WINDOW & ENTRANCE REPLACEMENT

**BOOTH HILL ELEMENTARY SCHOOL
544 BOOTH HILL ROAD
TRUMBULL, CT 06484
STATE PROJECT #144-0105 EC/CV
RFP #6301**

S/P+A PROJECT NO. 18.089

DATE: August 3, 2018

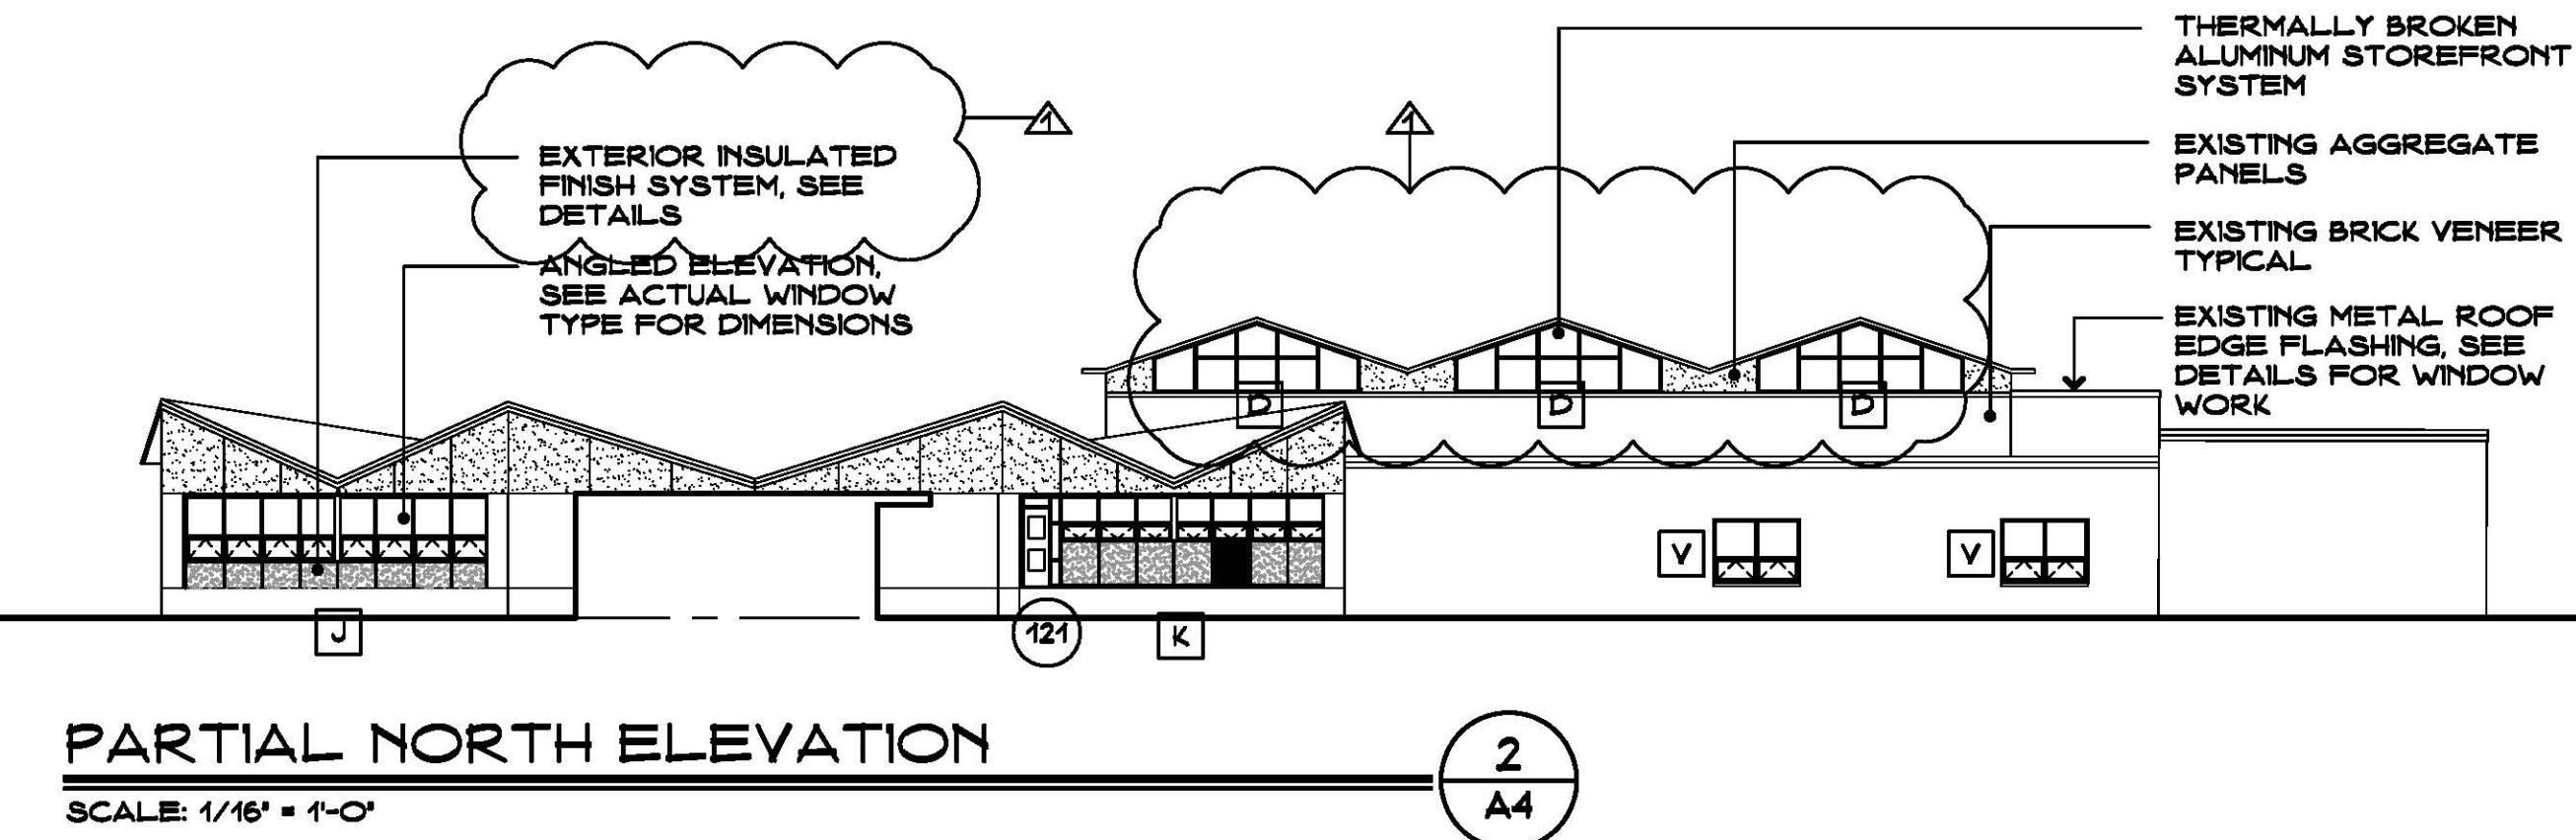
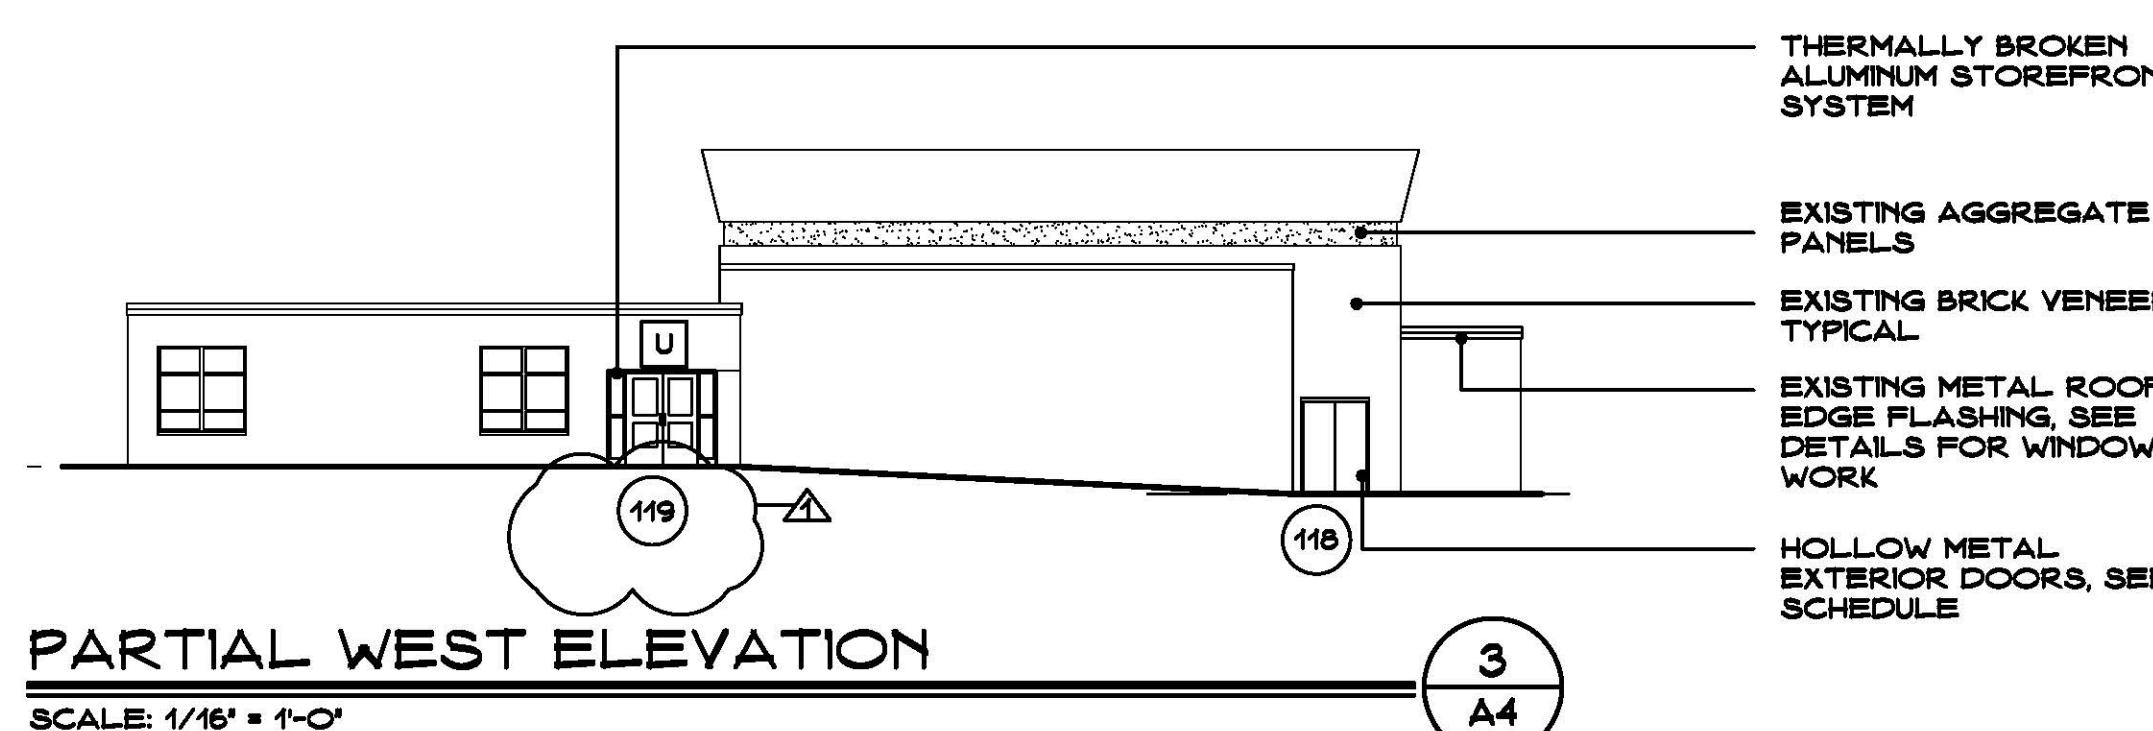
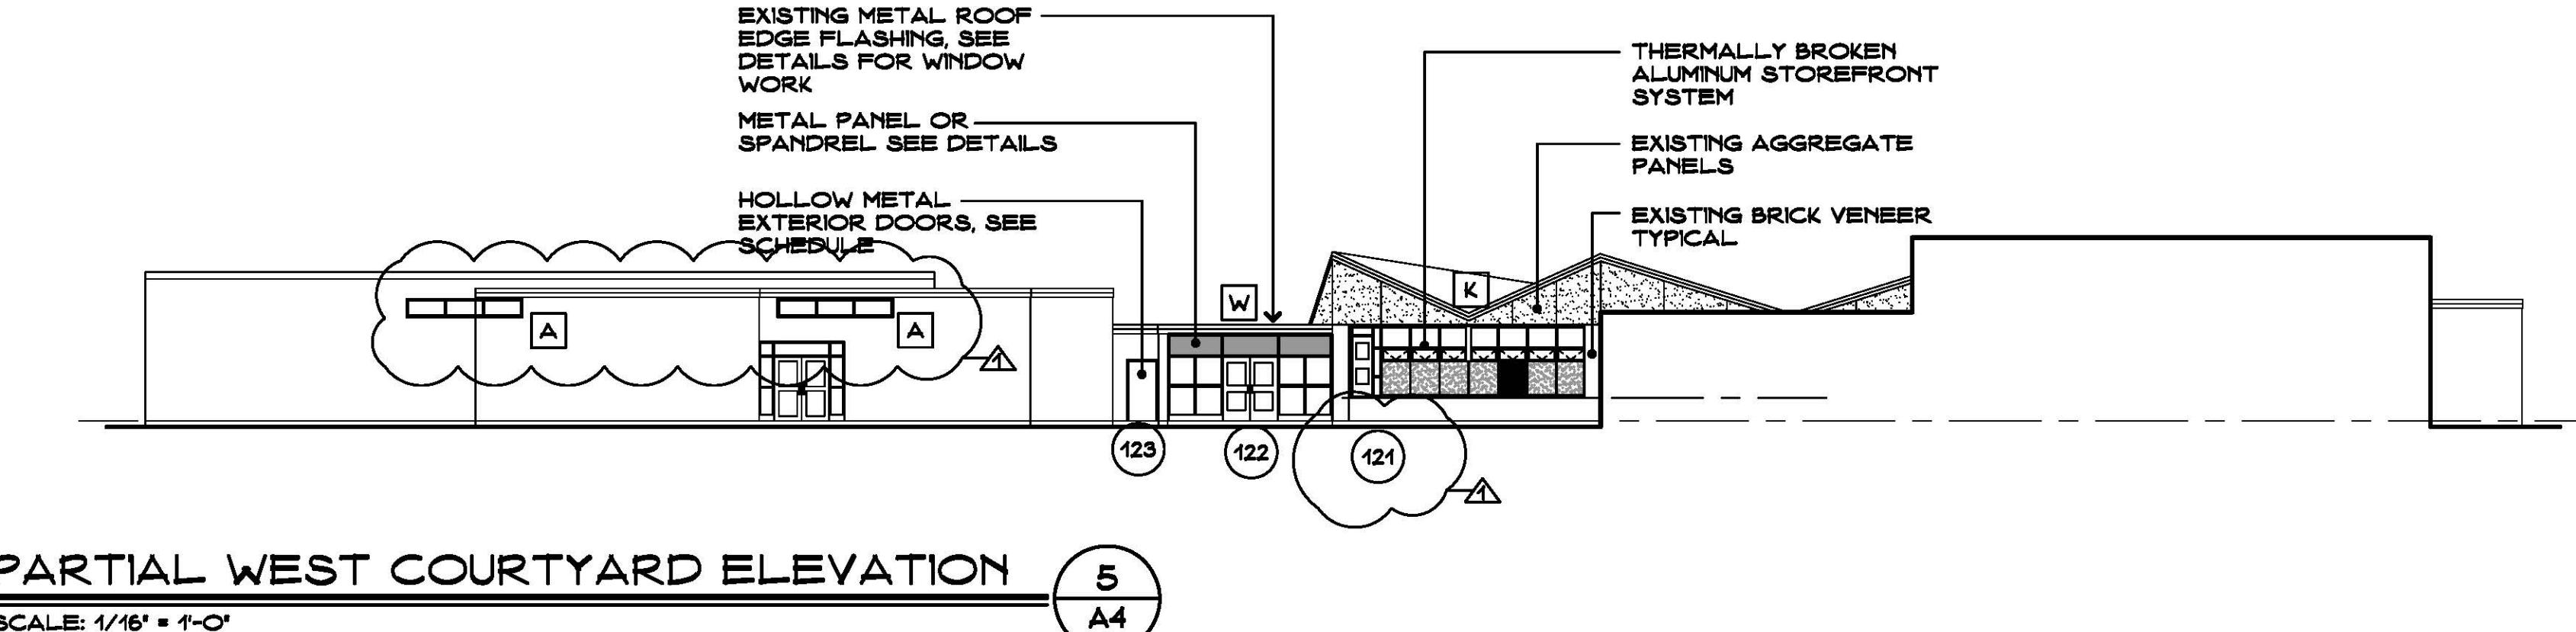
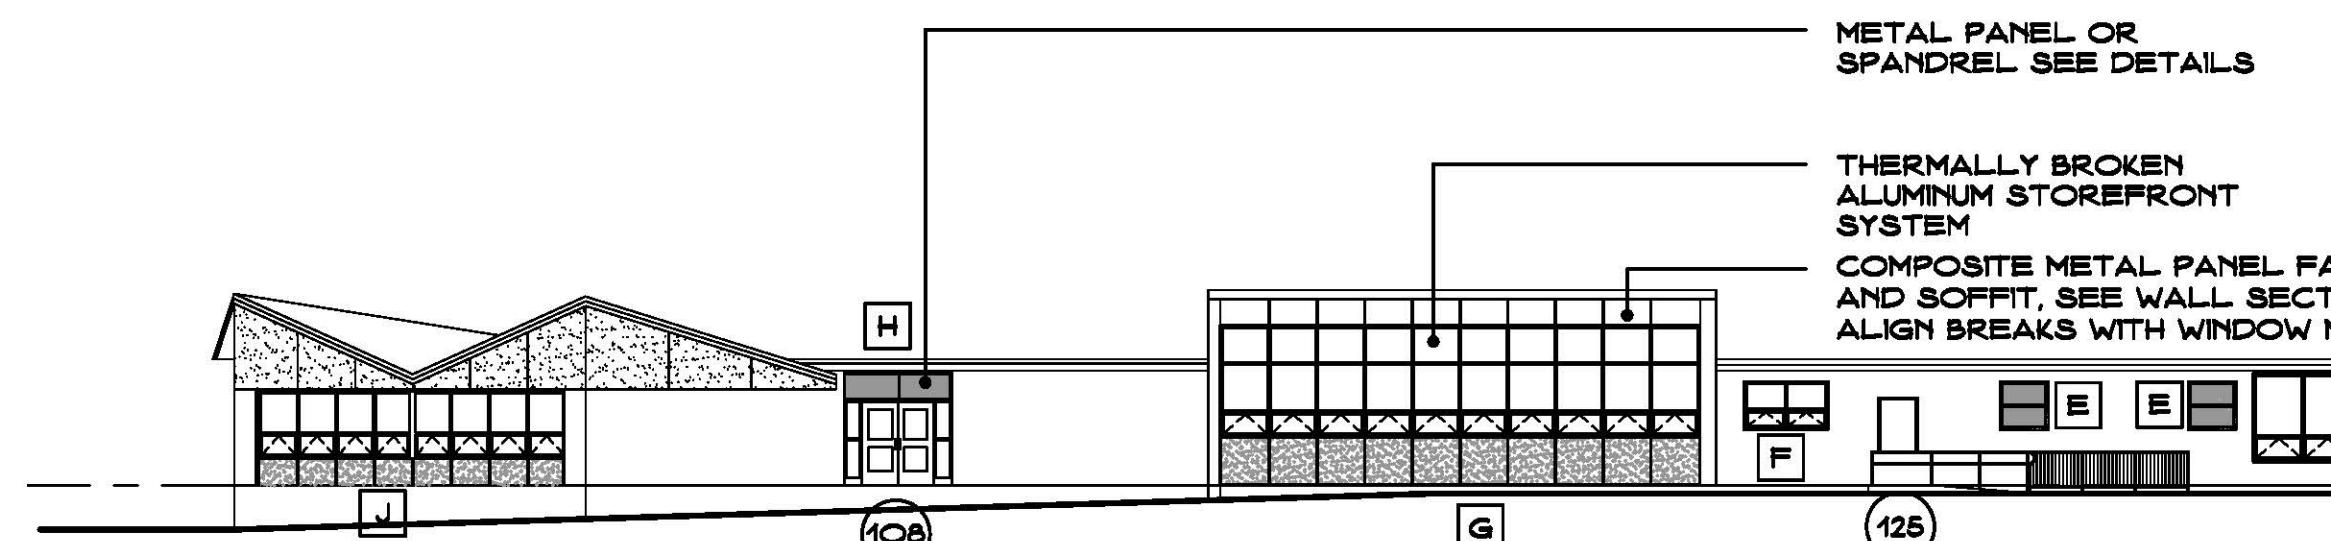
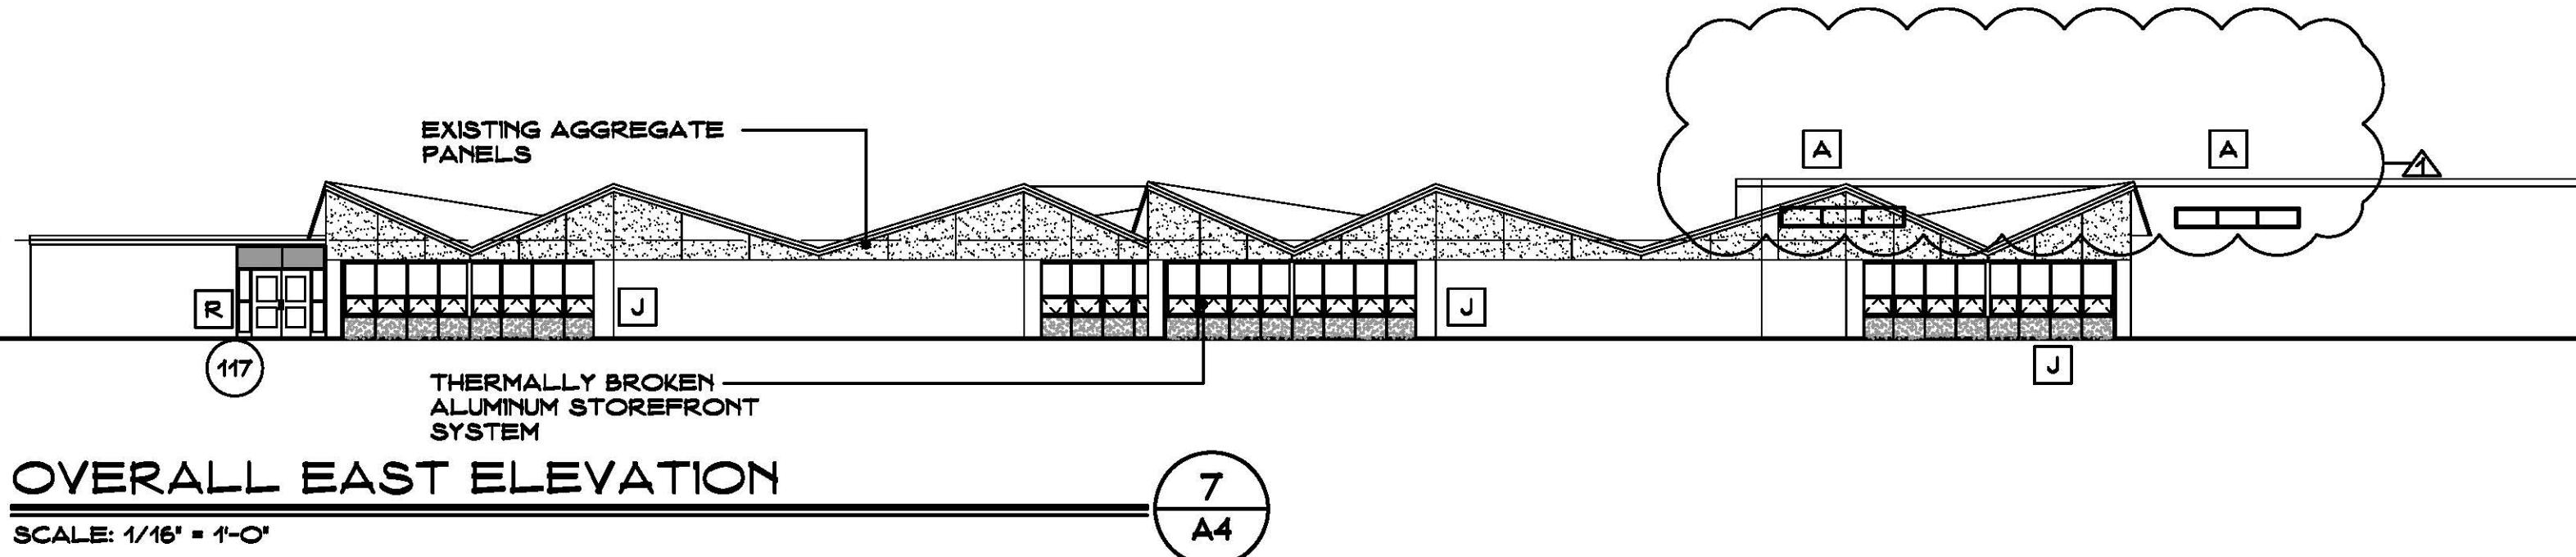
Q6: The floor plan and the elevations have different labels for the windows, what is correct the floor plan or the elevation?

Q7: The floor plan and elevations indicate more doors than the door schedule show, what is correct?

A6: Refer to the revised Drawing A4 included within this addendum.

A7: Refer to the revised Drawing A4 included within this addendum.

“Window Blinds:
-Reinstall on new wood trim. Provide Add Alternate for new blinds. See proj. man.” *(Per Owner/RFI Q8)*
- DRAWING A4, EXTERIOR ELEVATIONS has been deleted in its entirety. A new DRAWING A4 has been added and is attached as part of this addendum.* *(Per RFI Q6)*
- DRAWING A9, SCHEDULES & DETAILS, Door Schedule, Door 129, Door Type, revise “3” to read “1”. *(Per RFI Q6)*
